CR-Formv3	
CHANGE REQUEST	
✎ 25.225 CR 24 ✎ rev 1 ✎ Current version: 3.5.0 ✎

Title:	✎ Inclusion of 1.28Mcps TDD in TS 25.225	
Source:	✎ Siemens, CWTS, CATT	
Work item code:	✎ LCRTDD	Date: ✎ 28.02.2001
Category:	✎ B	Release: ✎ REL-4
	Use <u>one</u> of the following categories: F (essential correction) A (corresponds to a correction in an earlier release) B (Addition of feature), C (Functional modification of feature) D (Editorial modification) Detailed explanations of the above categories can be found in 3GPP TR 21.900.	Use <u>one</u> of the following releases: 2 (GSM Phase 2) R96 (Release 1996) R97 (Release 1997) R98 (Release 1998) R99 (Release 1999) REL-4 (Release 4) REL-5 (Release 5)

Figure A.2: Possible idle periods in a subframe with two occupied timeslots

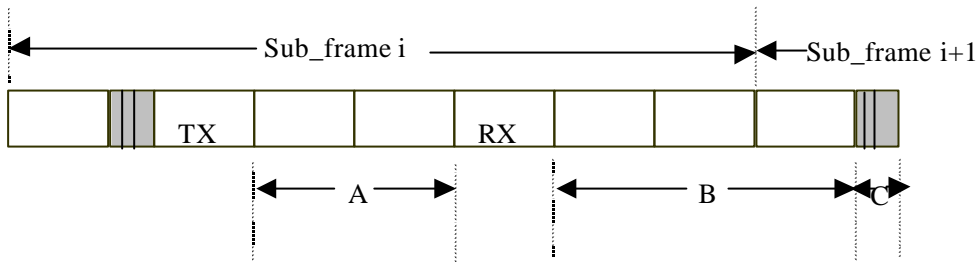
If a single synthesiser UE uses only one uplink and one downlink slot, e.g. for speech communication, the UE is not in transmit or receive state during 5 slots in each frame. According to the timeslot numbers allocated to the traffic, this period can be split into two continuous idle intervals A and B as shown in the figure below.

A is defined as the number of idle slots between the Tx and Rx slots and B the number of idle slots between the Rx and Tx slots. It is clear that $A+B=5$ time slots and C is equal to the DwPTS+GP+UpPTS.

In the scope of low cost terminals, a [0.5] ms period is supposed to be required to perform a frequency jump from 1.28Mcps TDD to GSM and vice versa. This lets possibly two free periods of $A*Timeslots-1$ ms and $B*Timeslots+C-1$ ms during which the mobile station can monitor GSM. Timeslots being the slot period.
